Administrative Approval Action

Abbington Village Apartments: SR-21-18,
Transaction# 547193, AA#3845

Design Adjustment Staff Response

**STREET "A" PLAN VIEW
CITY OF RALEIGH NEIGHBORHOOD STREET**

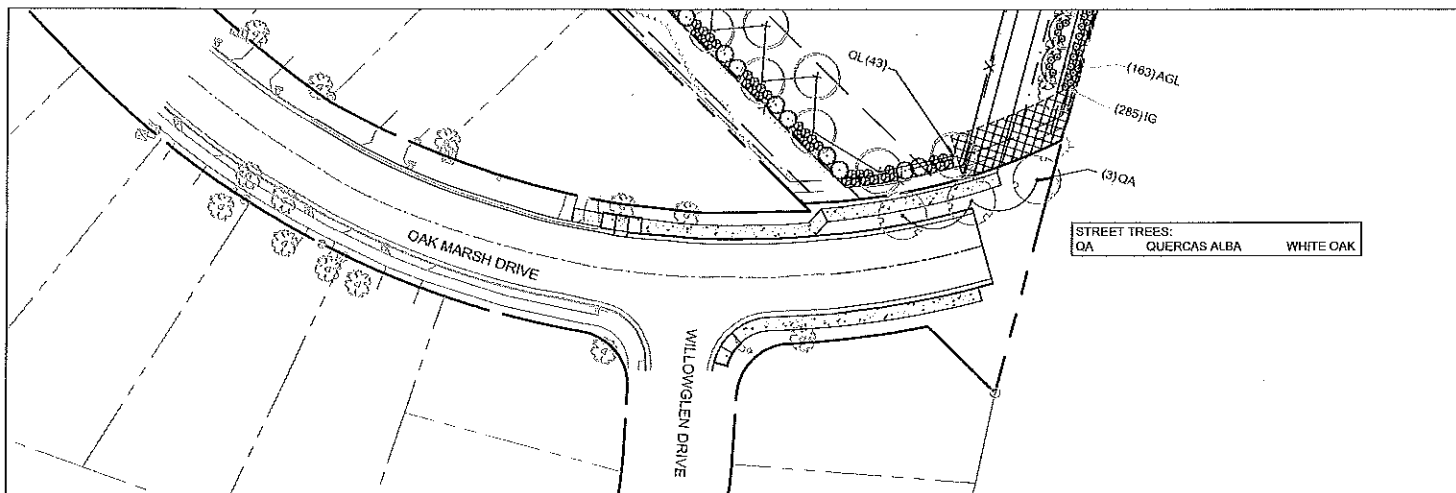
We are requesting a design adjustment for an approximate 80' extension of an existing public street, Oak Marsh Drive, on the south side of this project for a variation from the sidewalk location, listed under Section 11.2 of the Street Design Manual and Section 8.4 of the City of Raleigh UDO from the Neighborhood Street design requirements and Tree Planting, Section 11.2.5 of the Street Design Manual and Section 8.4 of the City of Raleigh UDO.

- 1) On the north half of the widening, Neighborhood Street section requirements will be met
- 2) On the south side the Neighborhood Street back of curb to back of curb requirement will be met
- 3) On the south side, due to existing right of way line location, the 6' sidewalk will be placed at the back of curb so no planting strip will be provided
- 4) On the south side, streetscape tree plantings will not be provided as no planting strip will be planted.

Oak Marsh Drive is currently constructed in such a fashion that the parameters meet that of a Neighborhood Local street section at a design speed of 25 MPH. Staff has determined Oak Marsh Drive is a Neighborhood Street section under the guidelines of the current Raleigh Comprehensive Plan and Raleigh Unified Development Ordinance. The developer is extending Oak Marsh Drive by a length of approximately 80 feet. Creating a section meeting the Neighborhood Street section is not feasible considering the existing parameters and limited length of road extension.

Oak Marsh Drive is currently constructed in such a fashion that the parameters meet that of a Neighborhood Local street section at a design speed of 25 MPH. Staff has determined Oak Marsh Drive is a Neighborhood Street section under the guidelines of the current Raleigh Comprehensive Plan and Raleigh Unified Development Ordinance. The developer is extending Oak Marsh Drive by a length of approximately 80 feet. Creating a section meeting the Neighborhood Street section is not feasible considering the existing parameters and limited length of road extension.
